**ADDENDUM NO. 2**

March 5, 2013

**DTCC OFFICE OF THE PRESIDENT****BID PACKAGE B**

Dover, Delaware 19904

# 1 FIRST FLOOR PLAN

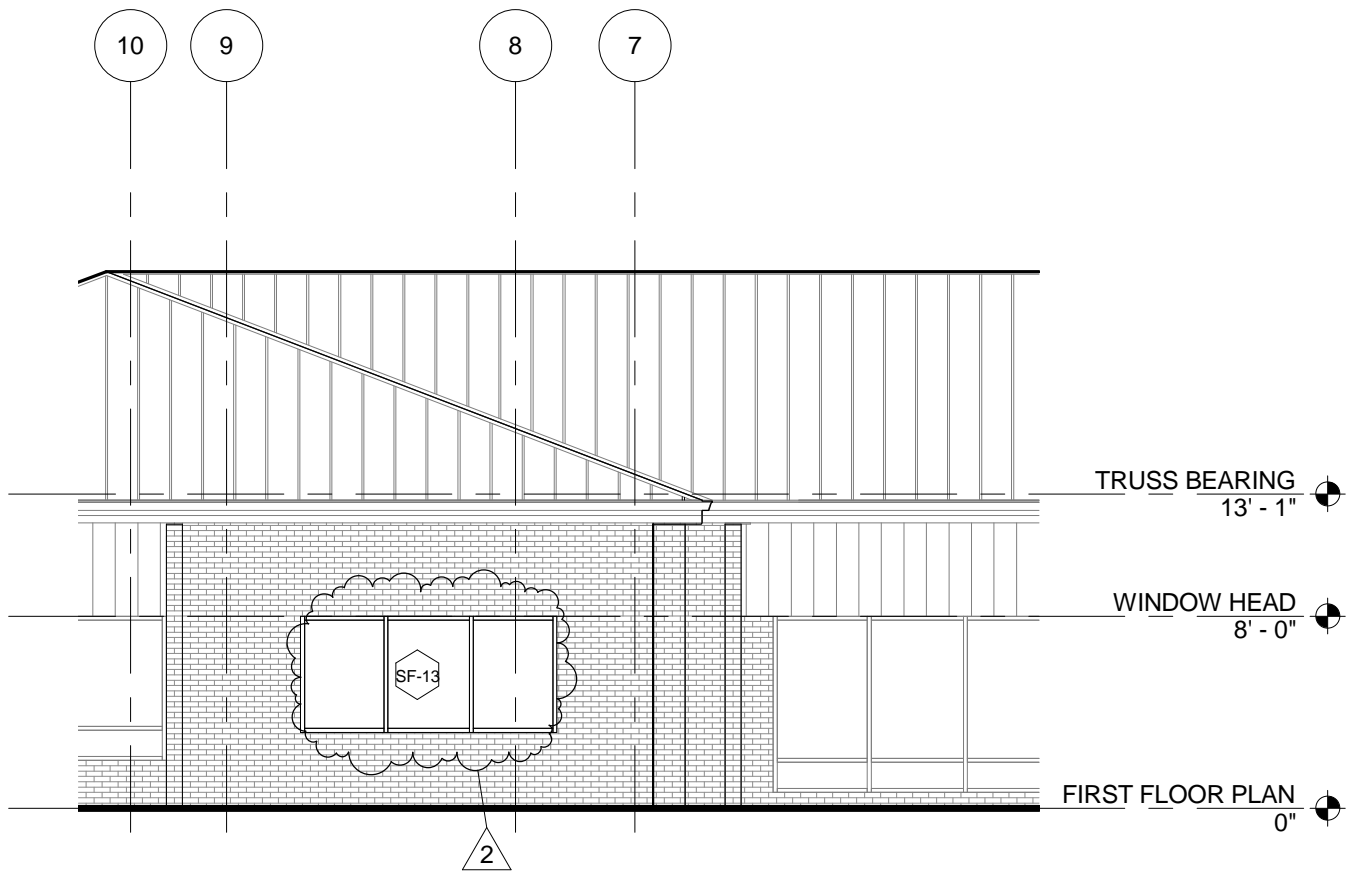
- First Floor Plan No. 1:
  - Delete room layout for room 101 as shown, Substitute revised room layout as indicated in drawing SKA-101-2, dated 03/01/13.

## 2 EAST ELEVATION

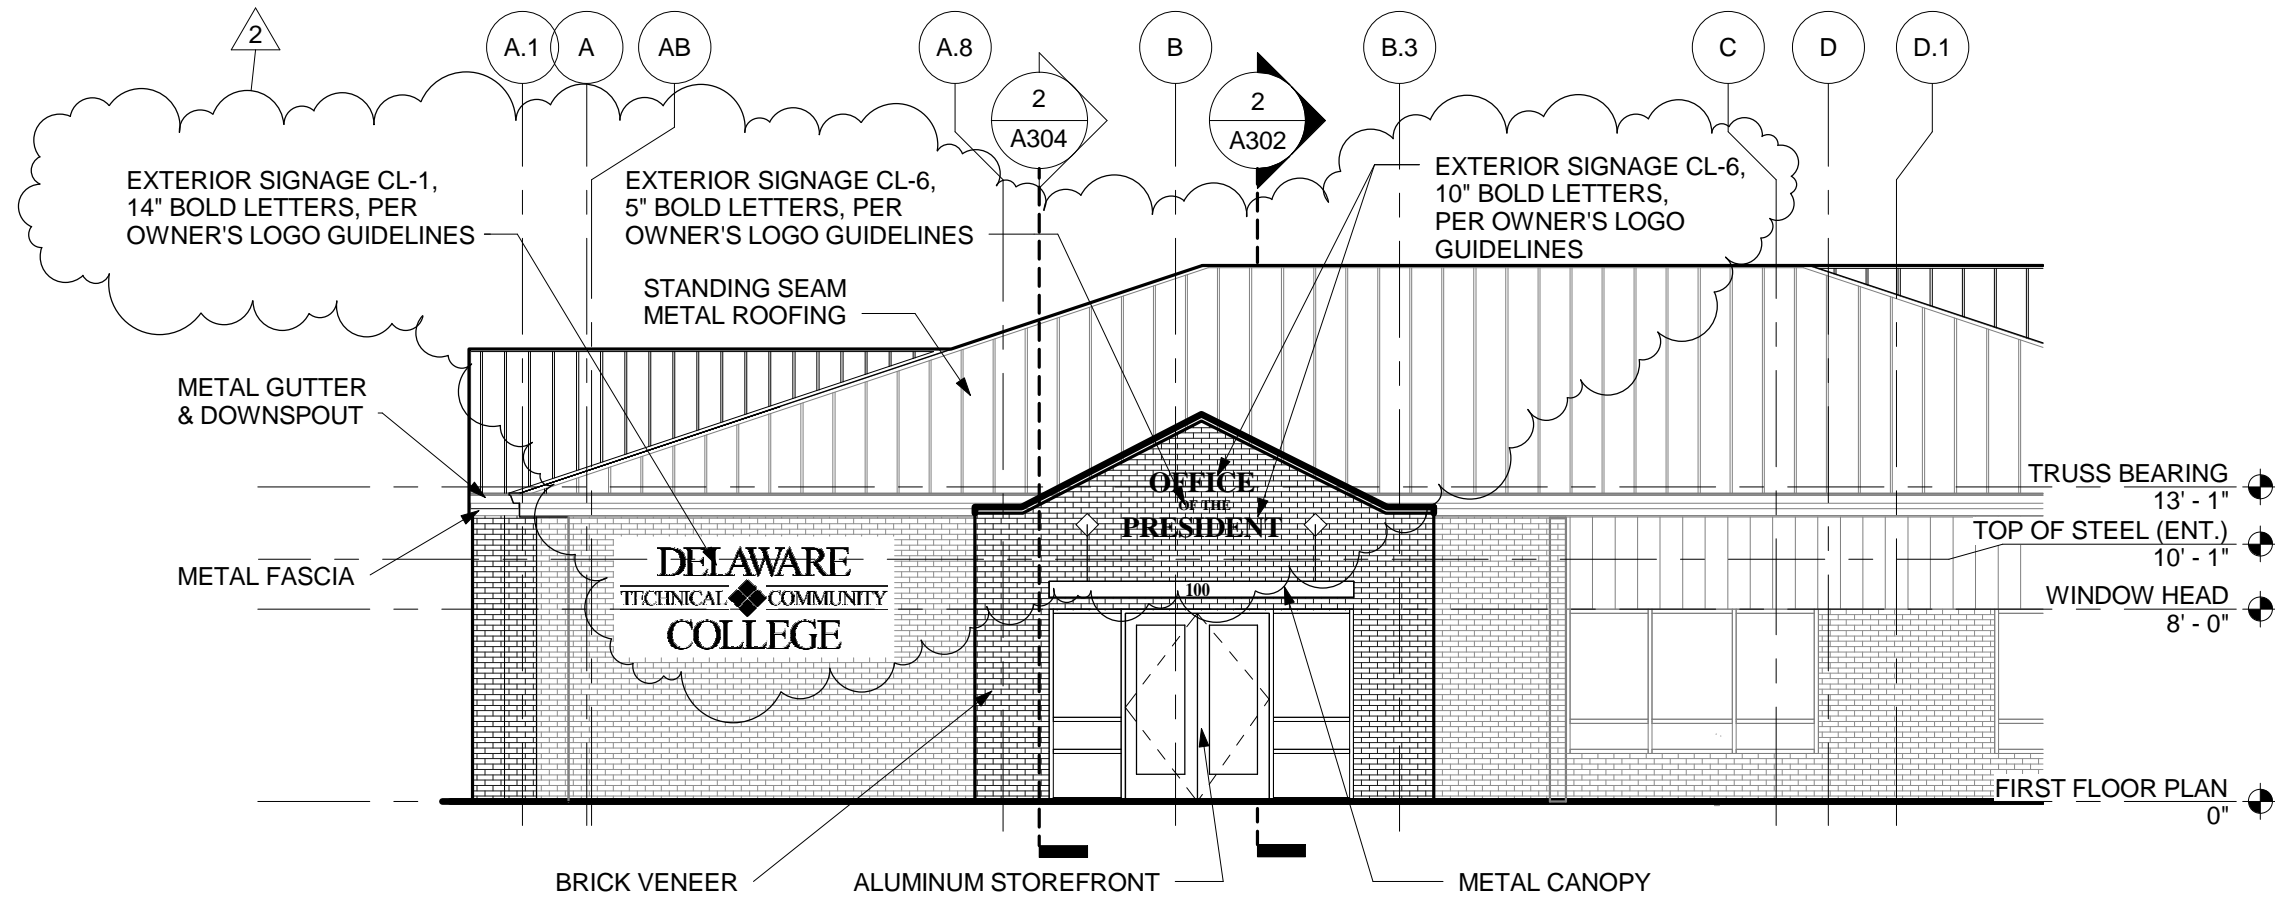
- South Elevation No. 1:
  - Delete Signs CL-1 & CL-4, Substitute revised signs as indicated in drawing SKA-201-2, dated 03/01/13.
- East Elevation No. 2:
  - Provide new window as indicated in drawing SKA-201-1, dated 03/01/13.

## 8 STOREFRONT SILL @ BRICK

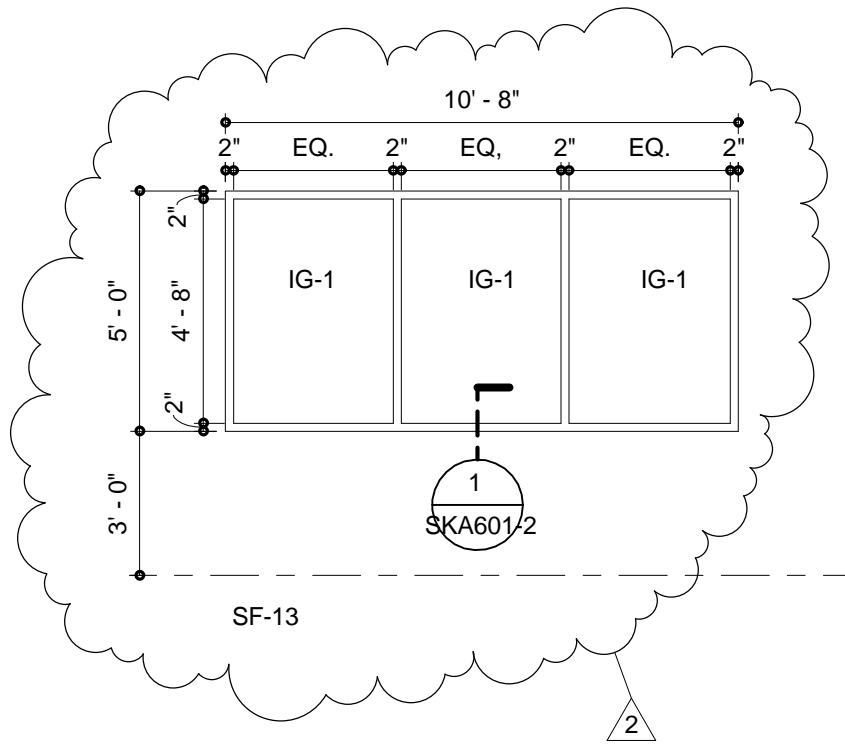
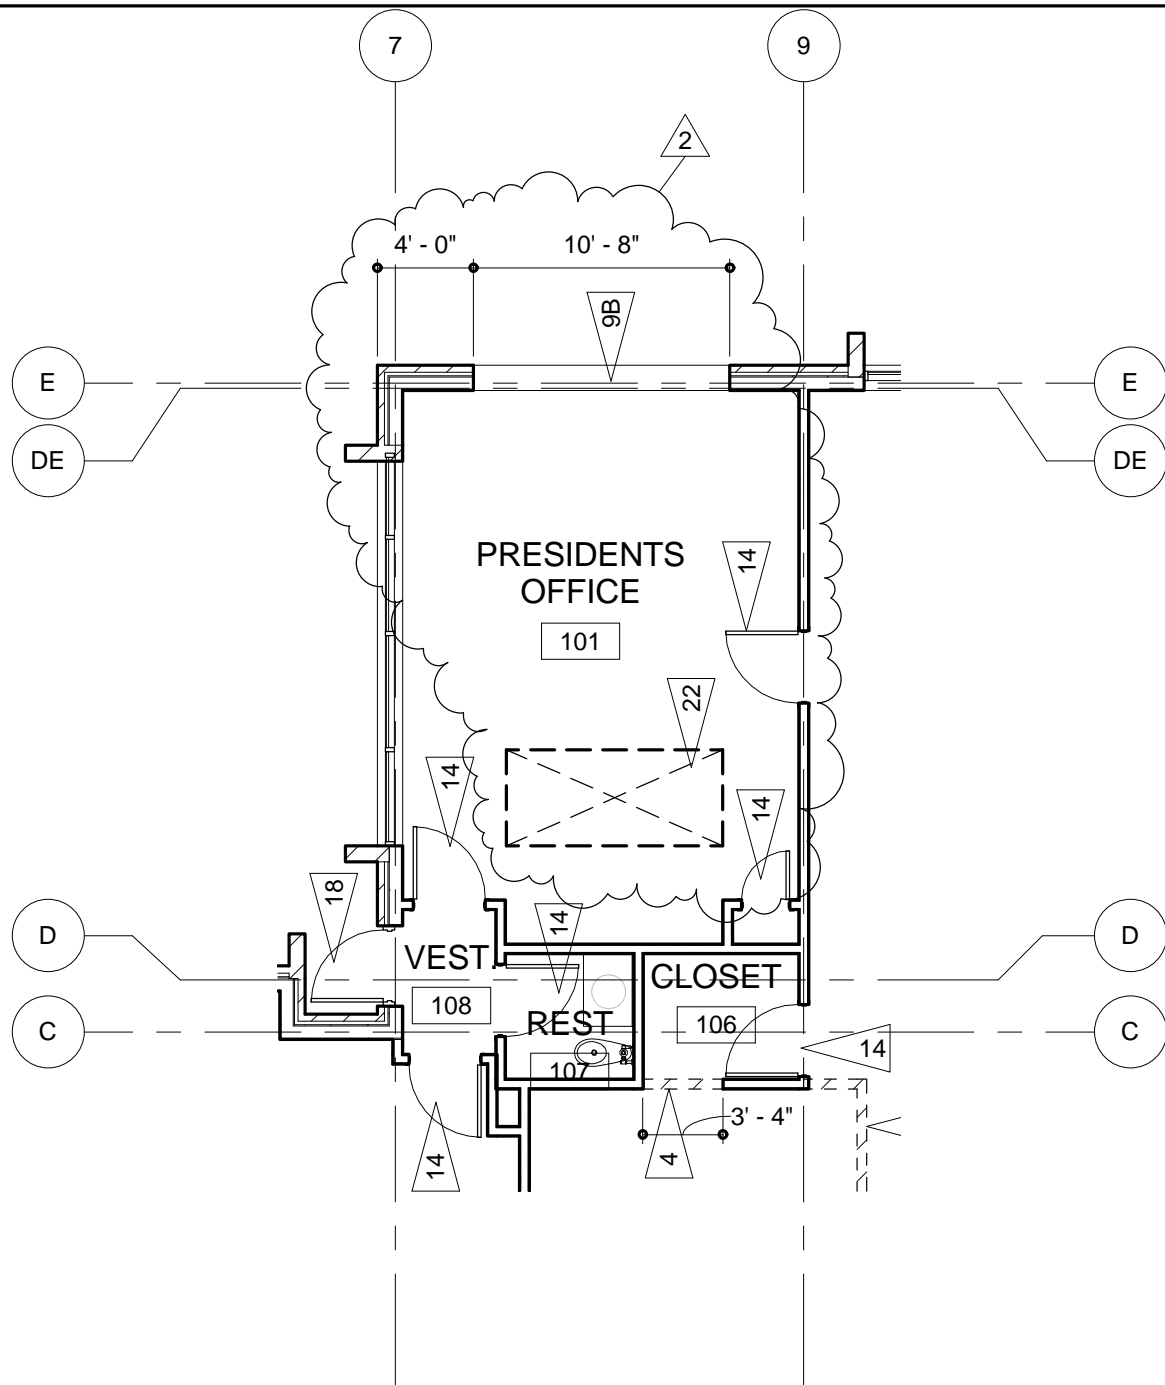
- Delete Storefront Sill @ Brick Detail No 8 in its entirety, Substitute revise detail as indicated in drawing SKA-503-1, dated 03/01/13.

## WINDOW/STOREFRONT TYPES

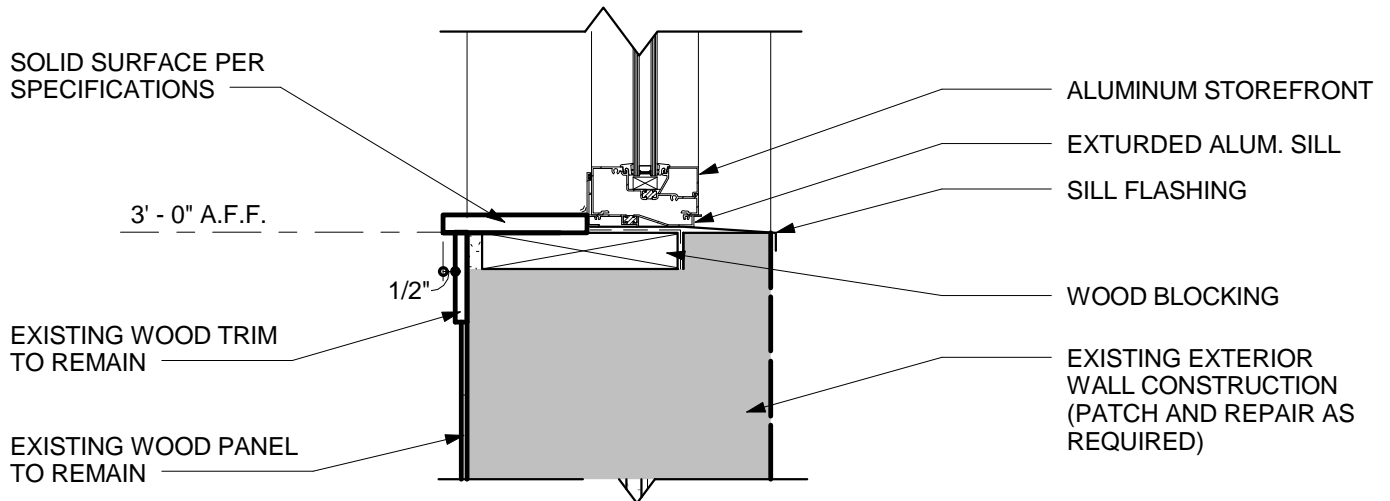
- Add Window/Storefront Type SF-13 as indicated in drawing SKA-601-2, dated 03/01/13.
- Delete 6" style width as indicated on Door Type B, Substitute 5".
